Re: Tract N-1-B Watershed Subdivison - Sketch Plat Submittal

PLAT OF
TRACTS N-1-A & N-1-B
WATERSHED SUBDIVISION
(A REPLAT OF TRACT N-1,
WATERSHED SUBDIVISION)
PROJECTED SECTIONS 17 AND 18,
TOWNSHIP 10 NORTH, RANGE 2 EAST,
N.M.P.M.
ALBUQUERQUE,
BERNALILLO COUNTY, NEW MEXICO
AUGUST, 2023

TRACTS N-1-B, WATERSHED SUBDIVISION zoned **PC**, located on **ARROYO VISTA** between **118TH ST** and **98TH ST** containing approximately 60.08 acre(s). (J-8)

Development Facilitation Team (DFT) – Review Comments

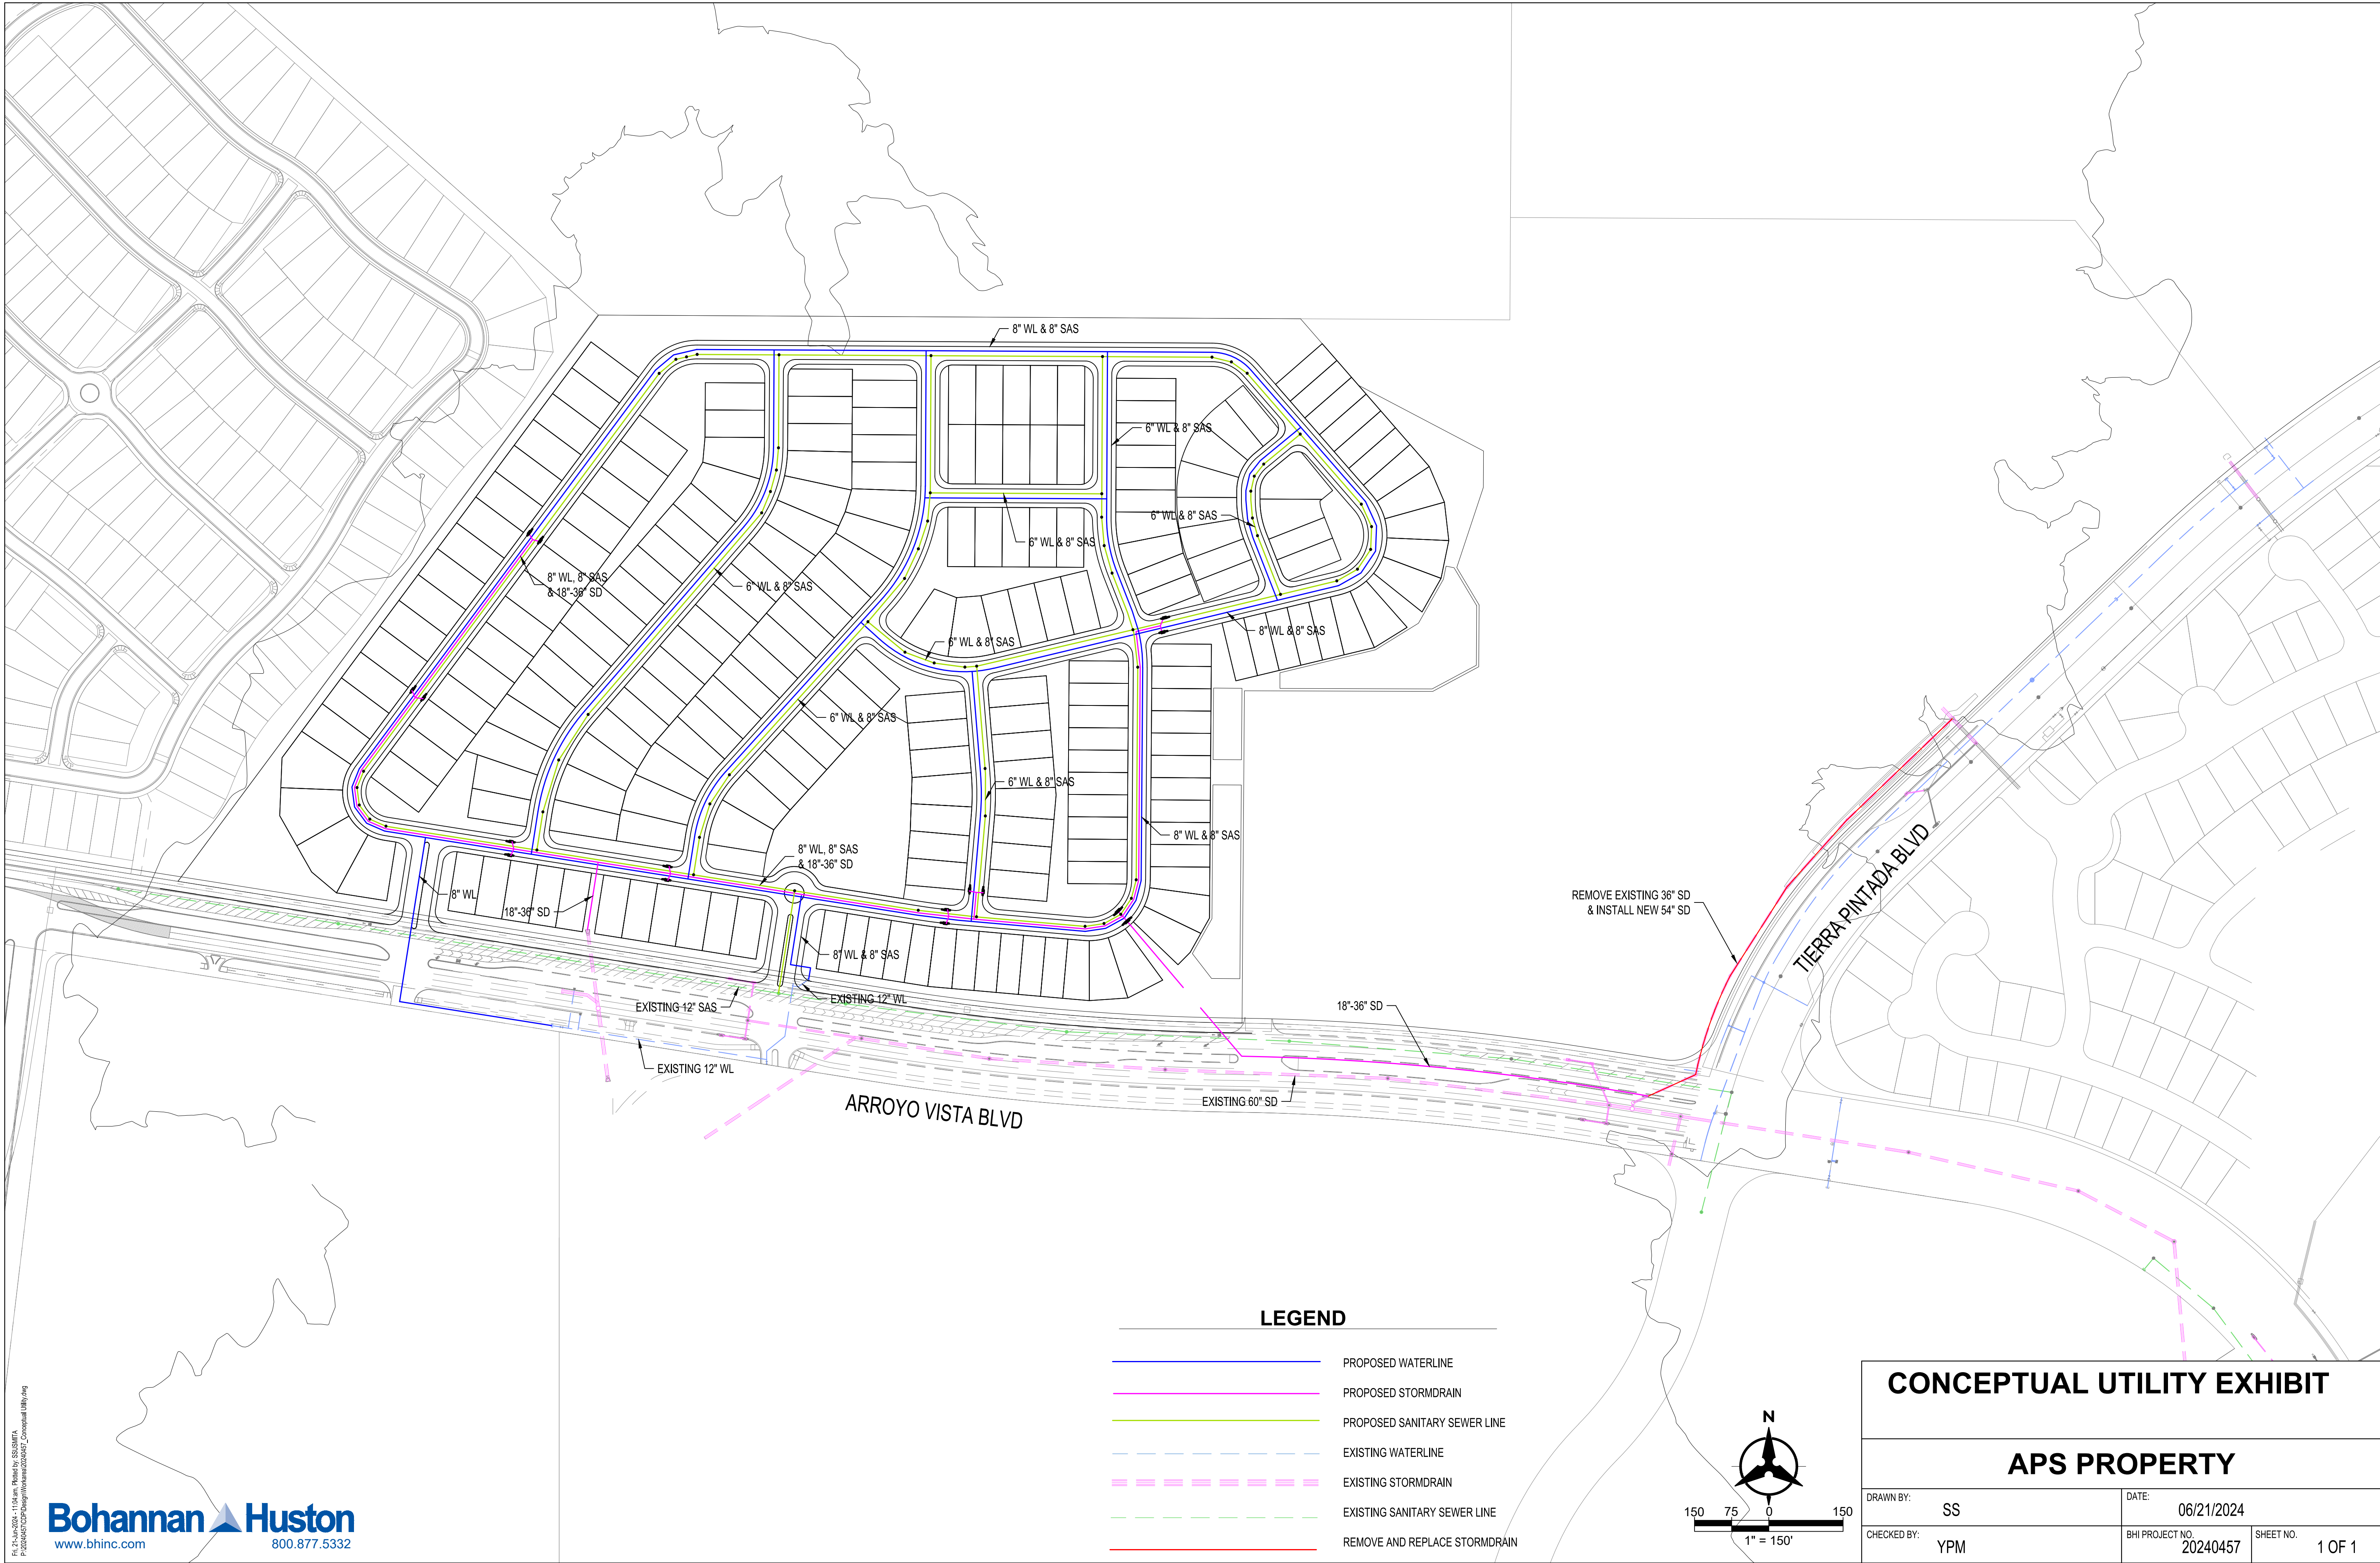
It is noted that a single-loaded street has been placed on the edge of the subdivision adjacent to Petroglyph National Monument which meets of the requirements of 5-2(J).

It would appear that you have been able to keep some block lengths under 600 feet, but some are not.
